**Economic and Social Council**Distr.: General
2 October 2017

Economic Commission for Europe**Inland Transport Committee****World Forum for Harmonization of Vehicle Regulations****Working Party on Brakes and Running Gear****Eighty-fifth session**

Regulation No. 79**Proposal for amendments to Regulation No. 79*****Submitted by the Working Party on Brakes and Running Gear***Regulation No. 79,**Insert a new paragraph 2.3.4.3., to read:*

Fig. 1

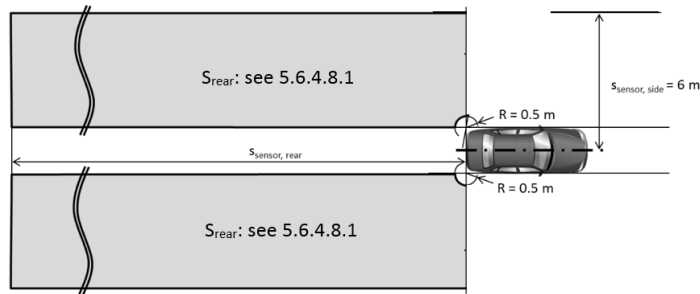
- 5.6.4.8.2. The vehicle system detection area on ground level shall be at minimum as shown in the figure below.
